Final Report

For:
**Stockport Metropolitan
Borough Council**

COPECAT Audit of A6 to Manchester Airport Relief Road Proposals

September 2013

Diagram 1. Woodford Road

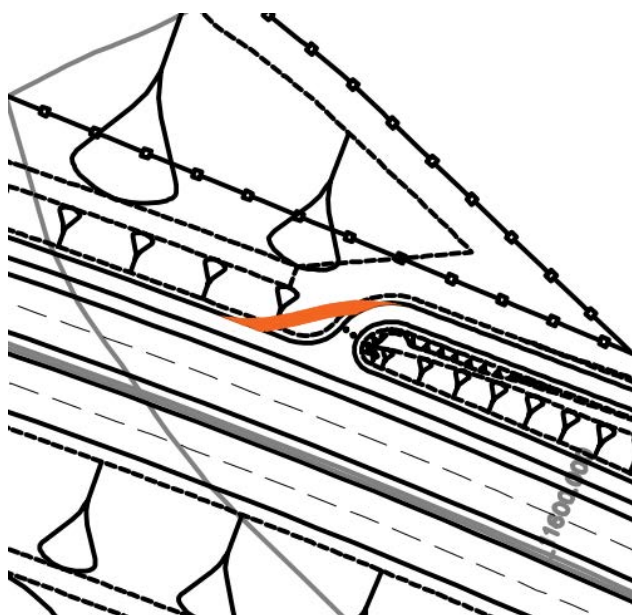
Cyclists prefer to make use of the speed they have gained going downhill rather than having to stop. The design of the road shows ramps leading down to the proposed cycletrack as turning sharply and meeting the cycle track almost at right angles. While this is a conventional highway design where motorists know they have to slow to give way, here cyclists will soon learn that the need to give way will be largely unnecessary and thus many will be tempted to use speed gained travelling down the ramp to help them along the cycle track. There is thus a possibility that they could overshoot the cycle path and verge to end up on the carriageway. It was originally recommended that the design should be altered to that shown in diagram 1.

However, in subsequent discussions, Stockport Council expressed some reservations about this. It is recommended that the Council reconsiders altering the alignment at these junctions. It is also recommended that the bollards shown on the plan are relocated to a straight section of path. The gap between the bollards should be 1.2m minimum and the line of bollards should extend beyond the width of the path as vehicles will be able to pass around them.

Diagram 2. Stanley Green

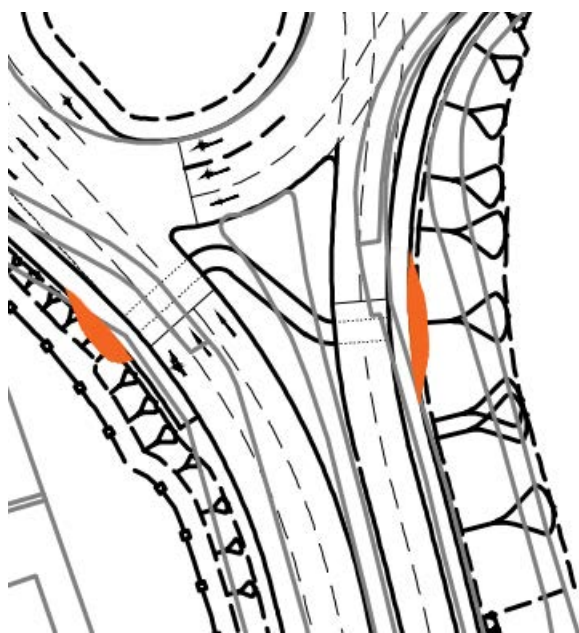
The drawings supplied show that the width of footways and cycletracks are the same at the ends of crossings as they are between them. Crossings can be conflict points as the signal poles use up some of the width and cyclists and pedestrians have to turn through 90 degrees to use the crossings. Often users travelling along the path will have to avoid those waiting thus, a wider path would be safer and more convenient to all users.

There are also some safety implications of having a tight turn onto the crossing. Where a cyclist (or pedestrian) is travelling in the same direction as general traffic before turning onto the crossing, a tight radius means they are less likely to be able to check whether traffic is actually stopping before they start to cross.

It is therefore recommended that, where possible, paths should be locally widened. Where they are in cuttings or on embankments this may require a short length of retaining wall. Consideration should be given to using cranked rather than straight poles to gain additional room.

*Diagram 3. Buxton Road West
Cyclists' routes shown in green
New path in orange*

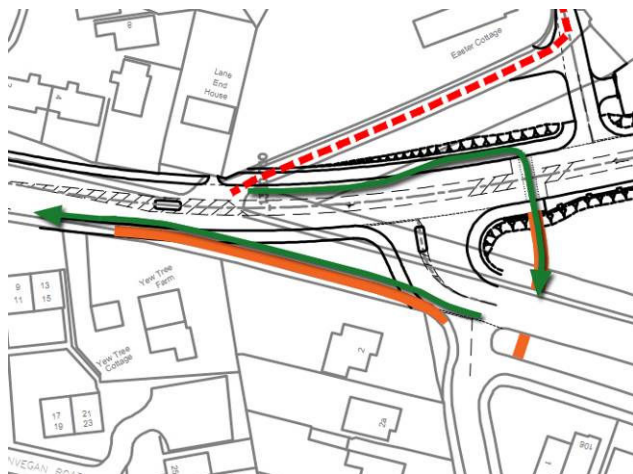
Some cyclists may prefer to use the new length of the A6, particularly in the eastbound direction. However most cyclists travelling east are likely to prefer to use the old line of the A6 or will be travelling to somewhere served by it. These cyclists will need to turn right at this junction. There is a crossing marked to the east of the junction. It is recommended that this is used as a toucan crossing to assist cyclists making the right turn. On the south east side of the junction there is no need for the footway to hug the kerb line. It could run straight across the grass area (subject to levels) thus giving cyclists and pedestrians a more direct, shorter route.

Failure to provide for 'desire lines' usually results in informal, worn, muddy paths developing as path users make up for the design deficiencies of the original layout. Westbound cyclists could be allowed to join the new line in a protected cycle lane which could run to a point just west of the road serving the police station. The footway does not need to hug the kerbline.

*Diagram 4.
Buxton Road East*

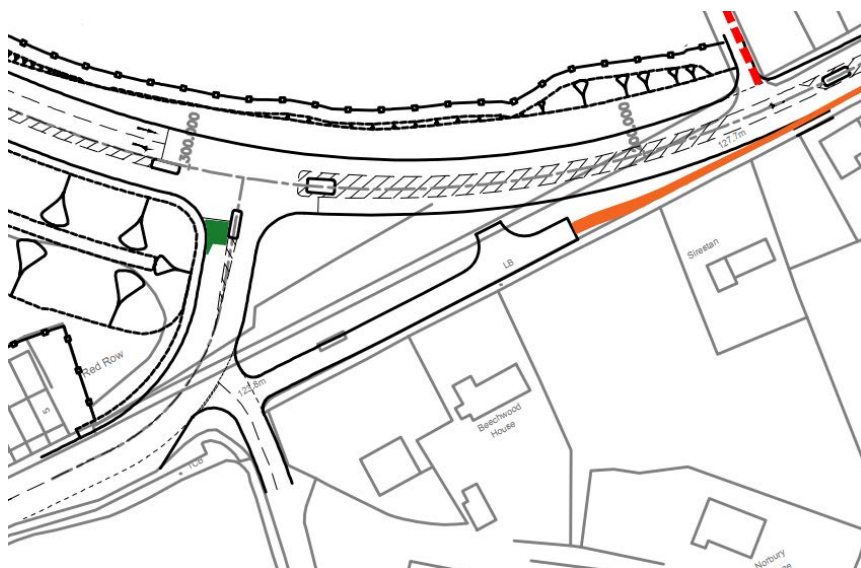
There are two ways cyclists might want to continue east up the A6. The first is on carriageway. It is recommended that an advanced stop line (ASL) is installed at this junction to make this turn easier. In 2005 Transport Initiatives investigated possible improvements for cycling along the A6 between Mill Lane and the Middlewood Way. One option considered

was to convert the southside footway to joint pedestrian and cycle use. This would be a preferred way for some cyclists (particularly less confident ones) to continue east towards the Middlewood Way. This idea was not recommended at the time due to the narrowness of the footway in the vicinity of Middlewood Road. The SEMMMS proposals enable this issue to be overcome as cyclists can use the new cul de sac alongside the 'problem' footway. It is recommended that the footway is converted to joint pedestrian and cycle use from the end of this cul de sac to the Middlewood Way. Parts of the footway will require widening. Flush kerb detailing at the transition point and measures to stop inconsiderate parking should also be included in any final design.

The flow along Middlewood Road is likely to be higher than that along Buxton Road which it joins and so motorists turning out may not pay sufficient attention to cyclists proceeding along Buxton Road. It is recommended that a length of green coloured advisory cycle lane is laid across the mouth of the junction to highlight the presence of cyclists.

Diagram 5. Old Mill Lane

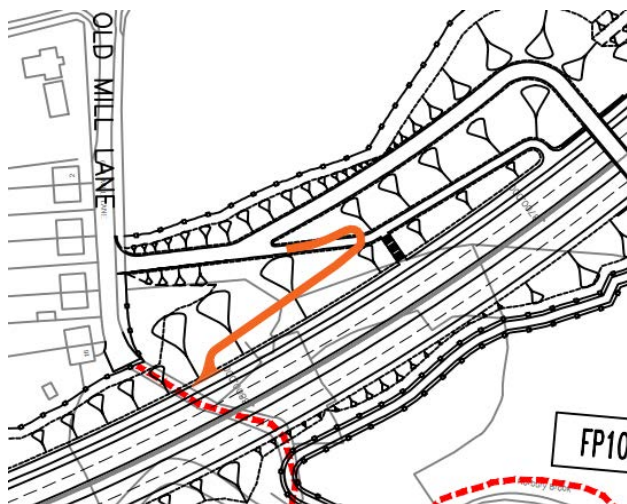
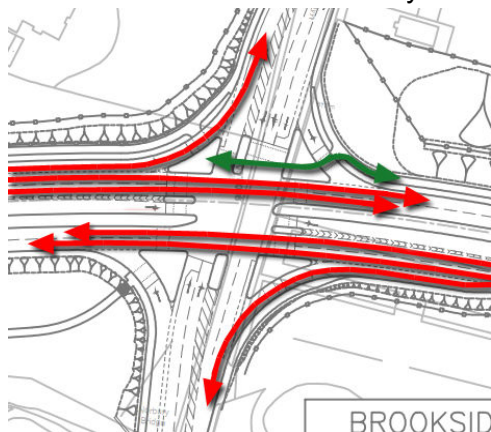
The ramp from Old Mill Lane to the A555 runs to the east. There is no benefit in cyclists using the Relief Road cycletrack to travel between Old Mill Lane and the eastern end of the scheme as remaining on the old road network is shorter and involves fewer gradients. While it is understood that the ramp's direction is dependant on more factors than just cycling, running the ramp in the other direction would shorten cycle journeys and add considerable convenience. It is therefore recommended that the Council review the direction of this ramp. It is also appreciated that the most the ramp could run to the west is shown on the diagram left.

Diagram 7
Macclesfield Road – Northbound Cyclists

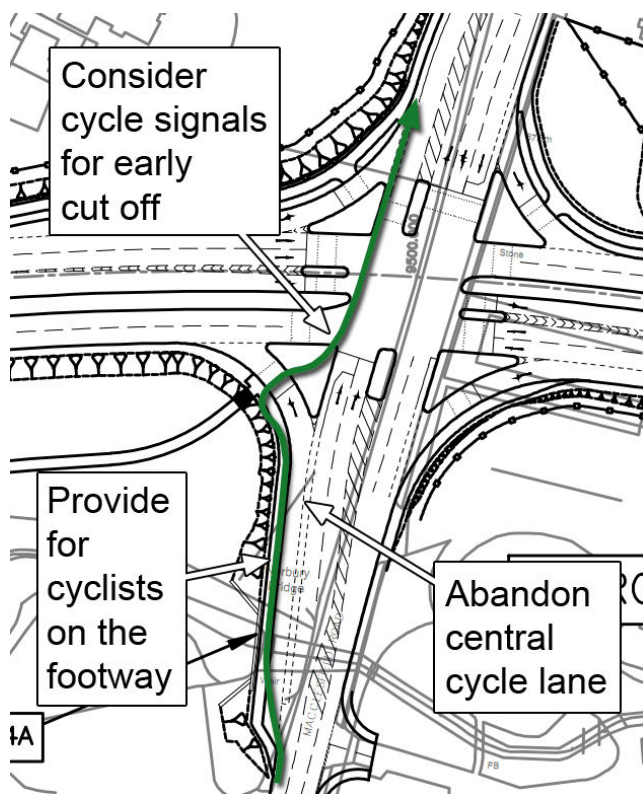
Both north and southbound cyclists cross the paths of vehicles turning left onto the new road. Judging by the long left turn lane it is expected that the northbound left turning flow will be substantial. Cyclists are likely to feel intimidated cycling on the long cycle lane between the left turning and straight ahead traffic. These long central lanes have also been associated with injury accidents to cyclists. It is recommended that the central cycle lane be abandoned and instead use a widened footway on the west side of the road, cross the left

turning traffic using a cycle/pedestrian crossing where the proposed pedestrian crossing is and then be returned to the carriageway to cross the remainder of the junction as designed. A cycle lane could be marked across the junction in both directions to guide cyclists. A slow cyclist could take a long time to clear the junction. The designers should consider a separate stop line after the jug handle crossing of the left turn flow which could be returned to red before the signals for the main northbound general traffic flow. An example of a jug handle crossing of a left turn slip using common straight ahead signals is on the westbound side of Ashton Old Road, Manchester, at its junction with the Mancunian Way. An example of a separately signalled jug handle is the northbound side of the A538 at junction 6 of the M56 west of Manchester Airport.

One issue that the current design fails to address adequately is that of cyclists on the east west cycle pedestrian path turning onto Macclesfield Road and vice versa. Coherent, convenient and legible facilities to enable cyclists to make these turns safely will need to be solved before the final design stage is completed. If this is not done, cyclists encountering the junction will need to devise their own, possibly dangerous ways to overcome the design shortcomings. It is recommended that the Council consider how these turns can be facilitated.

Diagram 8. Western end of Woodford Road bridge. New foot/cycleway shown in orange, cyclists and equestrian route in green.

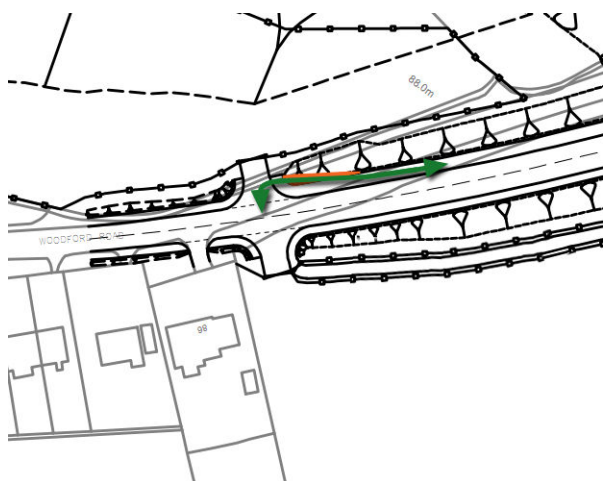
It is important that users can safely access the widened footway. Due to its short length it is unlikely to give benefit to cyclists travelling along Woodford Road. Thus we need to consider

cyclists and pedestrians (and maybe equestrians) turning onto the path from Woodford Road or crossing to the bridleway. A dropped kerb should be provided at the top of the ramp to the Relief Road path for cyclists wishing to travel to or from the north east. At the south western end of the bridge it is recommended that the foot/cycleway be realigned to make it easier for cyclists and horse riders to position themselves at 90 degrees to Woodford in order to cross. Effectively this allows them to make a larger radius turn. The Council also need to consider the gradient of the field access that cyclists and equestrians will be using.

The plan shows bollards at the ends of the access ramp. Presumably these are to prevent unauthorised use by motor vehicles. The clear space between the bollards should be 1.2m minimum. They should preferably be located on a straight section of the ramp and the line of bollards should be extended across any drivable verge.

The bottom end of the ramp is a location for the general suggestion that the design should allow east bound cyclists to join the ramp without losing speed and similarly that westbound cyclists using the ramp should be able to avoid braking more than necessary.

Diagram 9
Oil Terminal Junction
Chicanes

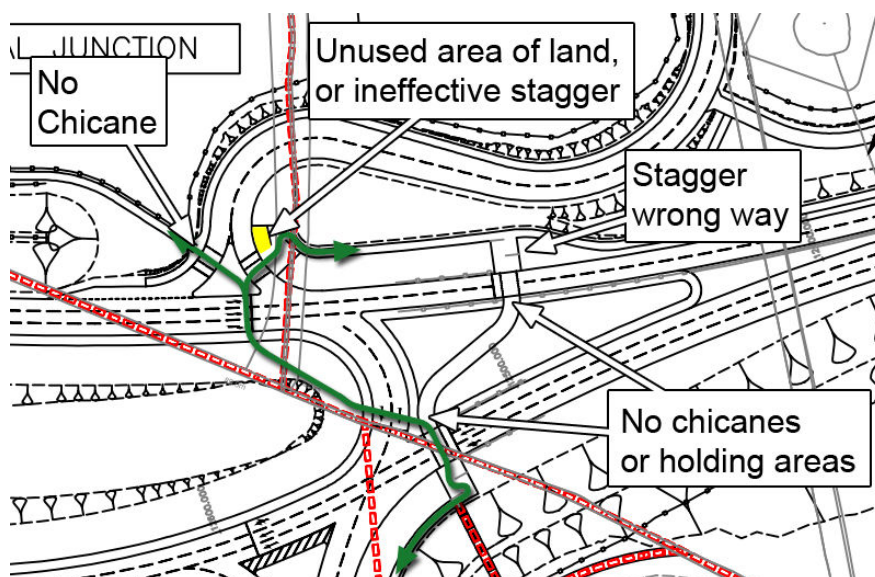
The design of this section includes a large number of chicanes, but not at all approaches to the pegasus crossing points. The Council needs to review this inconsistency. The staggered barriers forming the chicanes should be arranged so that the user crossing the road faces towards the oncoming traffic. While the chicane at the bottom of diagram 9 is correct the associated chicane on the eastbound carriageway is the wrong way round. The chicane at the exit of the Oil Terminal road is the correct way around but is poorly aligned with the crossing and so users face away from oncoming vehicles. The drawing supplied does not show guard railing. This would need to be installed or else users would make their own shorter routes to the crossings avoiding the chicanes. It is recommended that the Council consider the need for guardrailing to enforce use of the chicanes or review the need for the chicanes themselves.

Setting the path away from the road makes a more pleasant experience for users as well as ensuring horses are less likely to be 'spooked'.

Diagram 10
Oil Terminal Junction
Alternative route

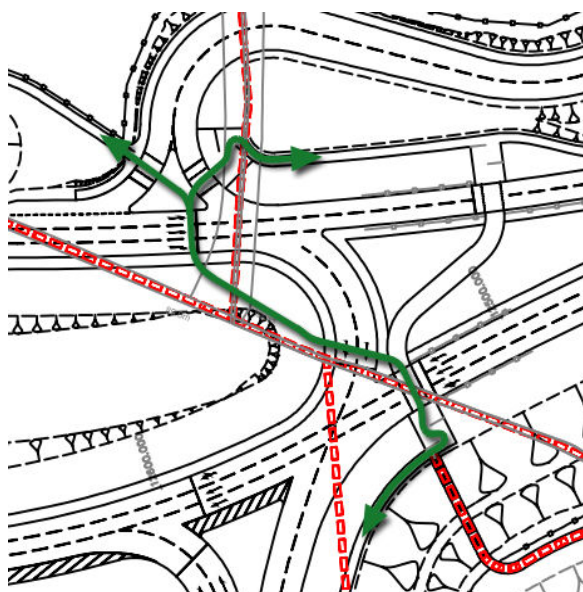
There is concern about the crossing of the eastbound carriageway that is set away from the junction. This crossing is likely to be lightly used. Regular users of the Relief Road who would normally see the traffic lights on green are less likely to react when they see them on red. A path taking the route as shown left may be quicker to use than one via the offset crossing but the need for storage for horses needs to be set against loss of storage space for vehicles making the west to south turn towards Chester Road.

However, having said the above, it may well be that the oil terminal will be relatively lightly used and thus the comments made regarding the safety of the offset crossing would also apply to the eastbound stopline within the junction. The Council should consider the safety implications of having an additional stopline set away from the Oil Terminal junction.

Diagram 11. Chester Road junction – right turn issues

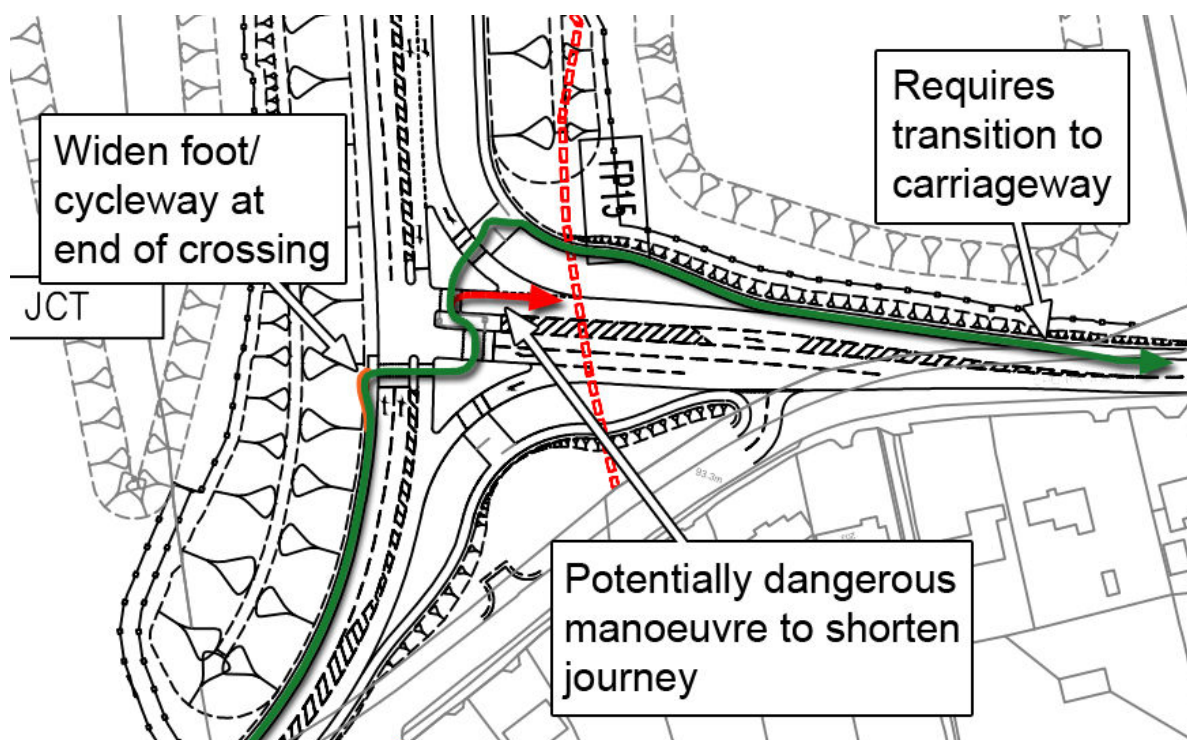
Of more concern is the number of steps that cyclists need to make to complete the right turn. There are various ways in which this junction could be signalled with different effects on the time taken for cyclists to get through it and some require more than one signal cycle. It would be expected that cyclists would treat the toucan and pegasus signals as "give ways" to reduce their delay and normally this does not give rise to accidents. However, designers should be wary of the turn shown in red in diagram 11, particularly if the signal regime chosen includes a stage where the north to east turn is running but not the south to east. In such a situation regular users would not expect to have to give way to any vehicle and so a bicycle, often not usually looked for by drivers, could easily be missed.

To enable cyclists to make the right turn in one step would require a redesign of the junction. It is recommended that the Council reconsider the south west to east cycle right turn at the junction.

Cyclists travelling south west to east on the carriageway could be assisted by an advanced stop line at the signals.

Diagram 12

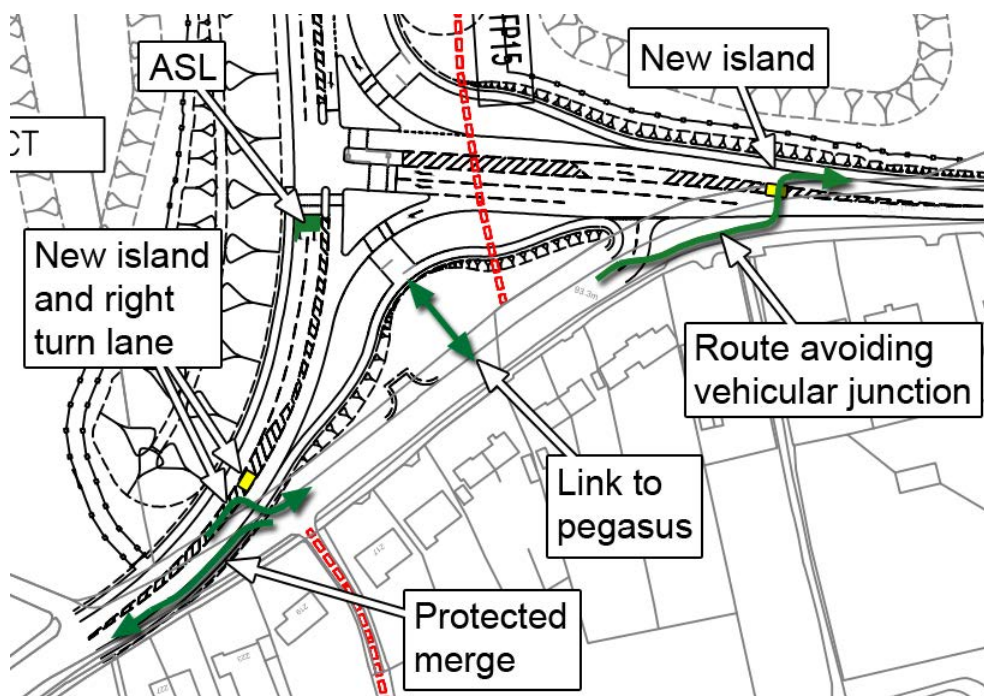
To enable westbound cyclists to rejoin Chester Road a gap in the footway would be required. There is however, space to construct a short length of cycle path ending in a cycle lane thus making it easier to rejoin the road without having to slow down more than necessary. The cycle lane would have to end at the point where the new alignment meets the old.

Some eastbound cyclists may prefer to avoid the junction altogether by following the line of the old road. In any case provision should be made for eastbound cyclists to use the old road as they may wish to visit a property on it. To assist eastbound cyclists to join the old section of road there should be a right turn lane in the area occupied by hatching, and further protected by an island. There will need to be a gap in the footway, this could be the same as the one used by westbound cyclists.

To rejoin Chester Road eastbound cyclists would have to cross 4½ traffic lanes. It would be safer to turn right in two stages where the road is narrower. It is therefore recommended that an additional island is constructed in the hatched area to the east of the proposed junction. The island should preferably be 2.5m wide. The exact position of the island will need to be determined at the final design stage; the further east it is, the easier the road will be to cross but the hatched area will be narrower. The link to this island should be constructed so that westbound cyclists can access and use it easily.

It is recommended that the Council improve the links between the old and new alignments.

There will need to be a link to the Pegasus crossing from the old line of road to enable cyclists to reach the link to the Relief Road.

Diagram 13 Woodford Road junction

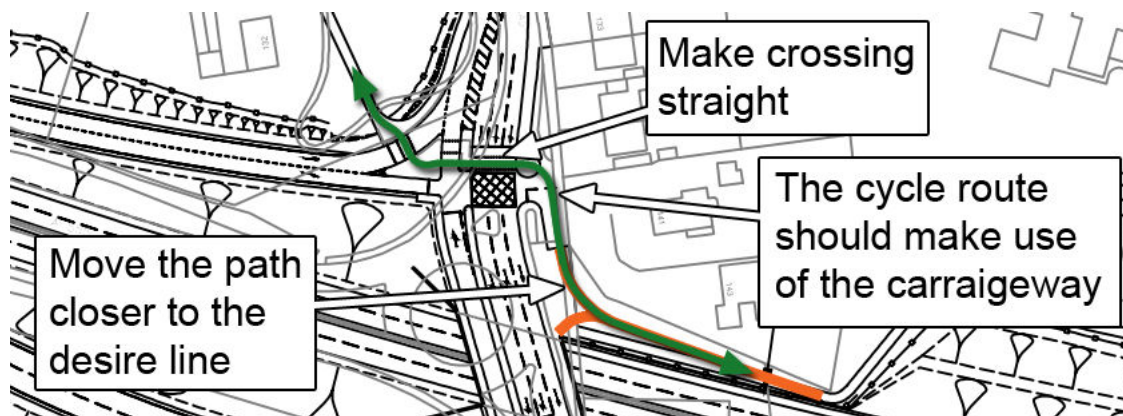
The Woodford Road junction is very tight with very little space for cyclists. The main issues for east west cyclists on the A555 route revolve around the crossing over Woodford Road. These are:

- a pinch point at the northern corner of the triangular island as the western half of the crossing is located very close to it
- a pinch point in the 'sheep pen' on the central island
- the tight dimensions of the cul de sac eastern arm of the junction means that there could easily be conflicting movements.

The path from the Oil Terminal junction runs parallel to the A555 whereas users are likely to want to take the natural direct line and cut the corner to get to the crossing.

It is recommended that the Council investigates the possibility of making the crossing over Woodford Road a one stage crossing rather than a two stage one. It could still run via an island upon which users could wait but cyclists could cross Woodford Road in one go. This would enable the western half of the crossing to be moved away from the corner of the triangular island.

East of the crossing, cyclists should use the carriageway of the cul de sac. They will need guiding both from the crossing and from the Oil Terminal direction, perhaps by short lengths of segregated path.

The path towards the Oil Terminal junction should be realigned to provide a shorter route.

Diagram 14

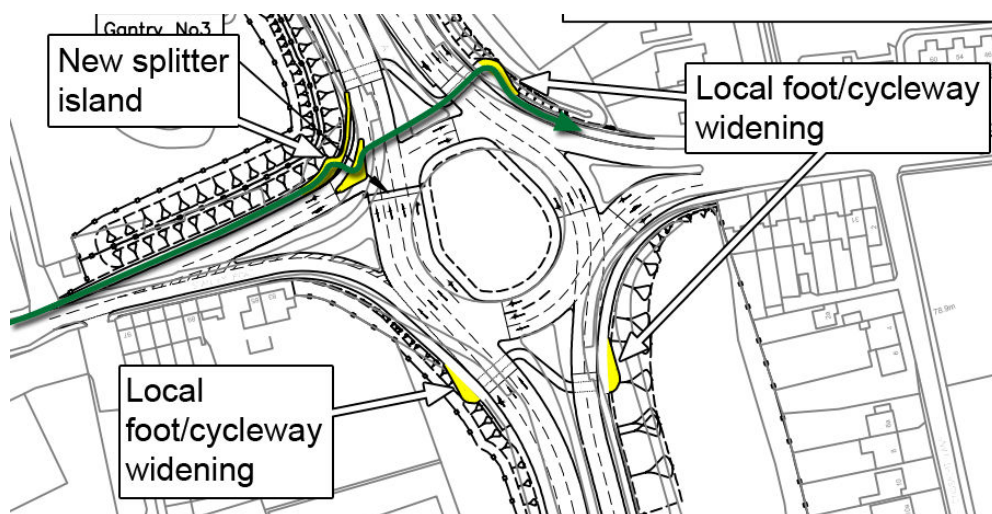
Cycle movements along Stanley Road are catered for by uni-directional facilities north and south of the junction. The eastbound route on the north side of the junction includes an offset toucan crossing. This increases the length of cyclists and pedestrian journeys and involves an additional stop with associated capacity lost for motor vehicles and potential for shunt and other accidents including see-through problems. The drawing supplied shows that the western approach to the junction is divided into two lanes with the left hand lane marked for turning left and the right hand lane for all other manoeuvres. If this is the case the two flows can be split by a triangular island allowing the offset toucan to be incorporated into the junction giving shorter journeys, a safer crossing and a pedestrian cycle crossing opportunity per signal cycle. It is recommended that this be investigated.

The transitions between the carriageway and foot/cycleway should be smooth so that a cyclist can leave the carriageway without having to slow appreciably and return to the carriageway in a protected cycle 'slip' lane. The foot/cycleway should be locally widened at the ends of the toucan crossings by providing a short length of retaining wall. Additionally, cranked poles should be used to increase the available width.
